**DEPARTMENT OF COMMUNITY DEVELOPMENT
Design Review Committee Agenda**

To: Design Review Committee
From: Jo Ann Hunter, Principal Planner
Date: September 26, 2016
Subject: COA-2016-00012 Page Audi

COA-2016-00012

Project: Audi Car Dealership (landscaping, site design, and lighting only)

EX. TREES TO REMAIN
(SUPPLEMENTAL LANDSCAPING MAY BE NECESSARY TO MEET MINIMUM COUNTY REQUIREMENT. SCHEDULE SITE MEETING WITH COUNTY PLANNER AND LANDSCAPE ARCHITECT AT THE COMPLETION OF CLEARING AND GRADING TO DETERMINE IF EXISTING VEGETATION MEETS MINIMUM REQUIREMENT.

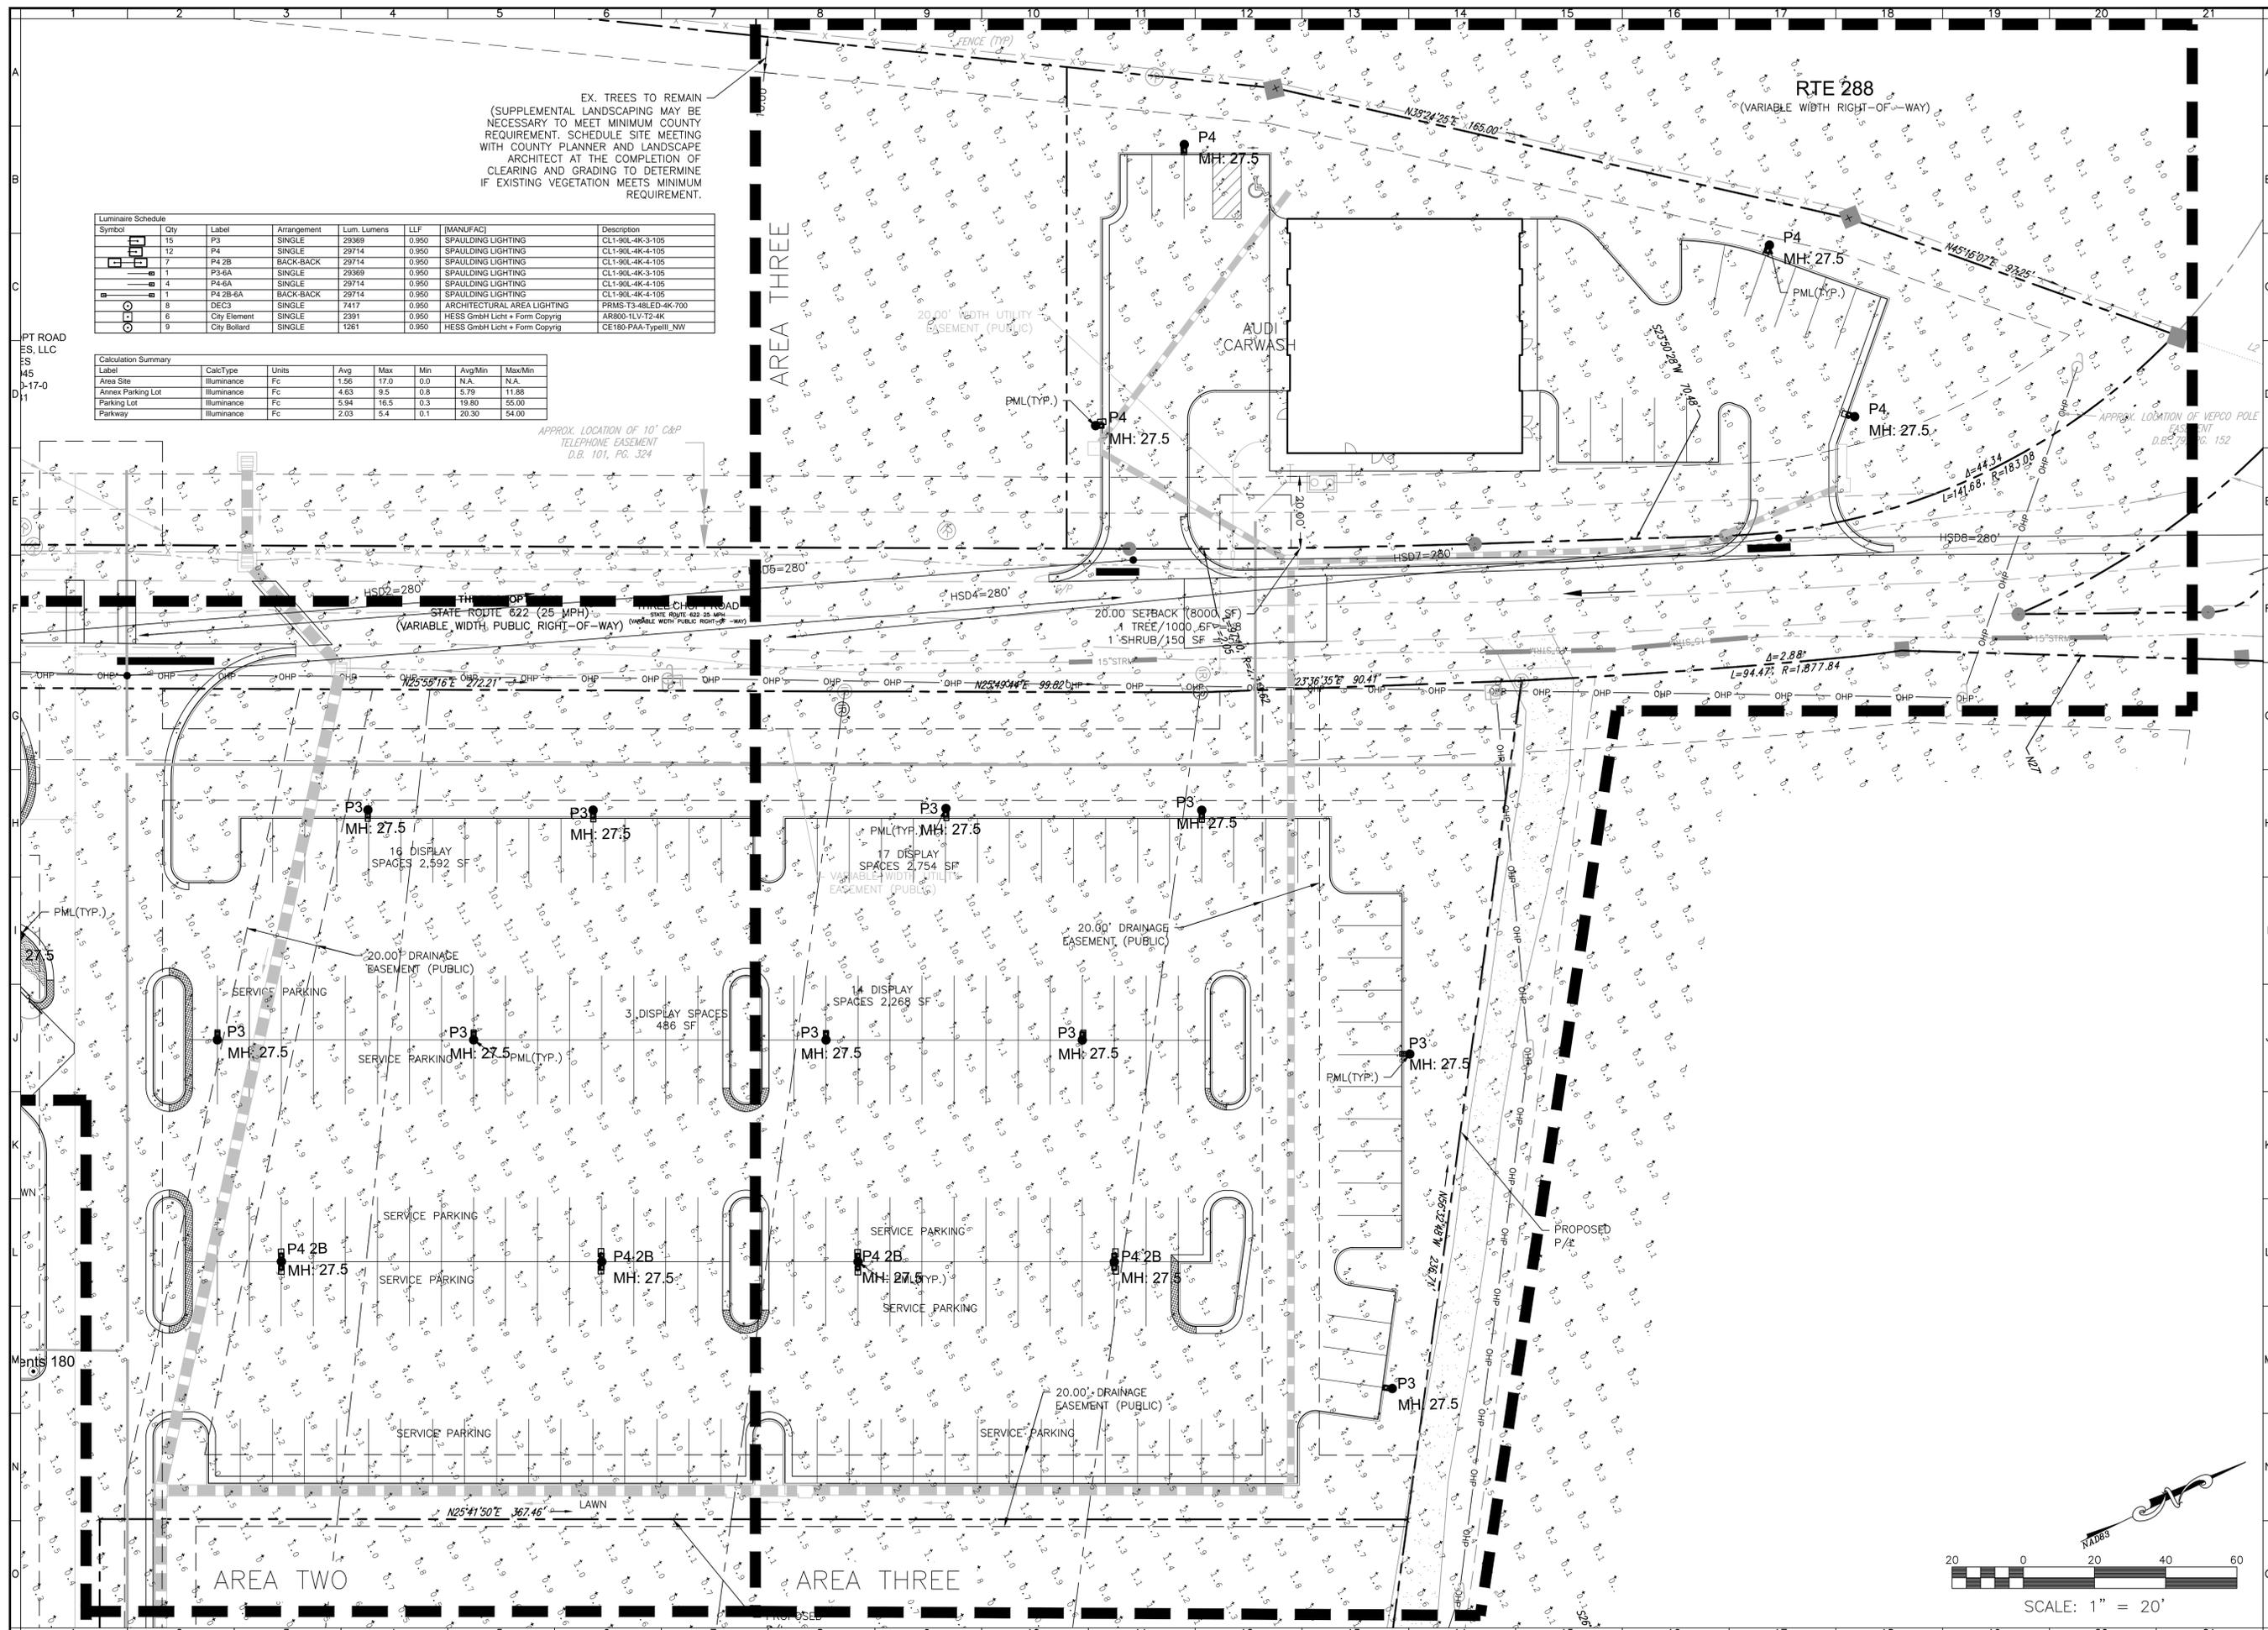
The County Code has a dark sky lighting ordinance. The applicant is proposing lighting fixtures that are approved by the International Dark Sky Association. The following revisions are required to meet Code requirements:

- Pole lighting must be reduced to 20'
- Light trespass cannot exceed .5 footcandle at all property lines

1. Improvements shall be in substantial conformance with the Landscape Plan submitted by Balzer and Associates dated 9/14/16 with revisions to the landscaping and lighting plan as discussed in this staff report.
2. Sign Package will be reviewed with a subsequent administrative Certificate of Approval application; however, sign base shall match the natural stone of the building.
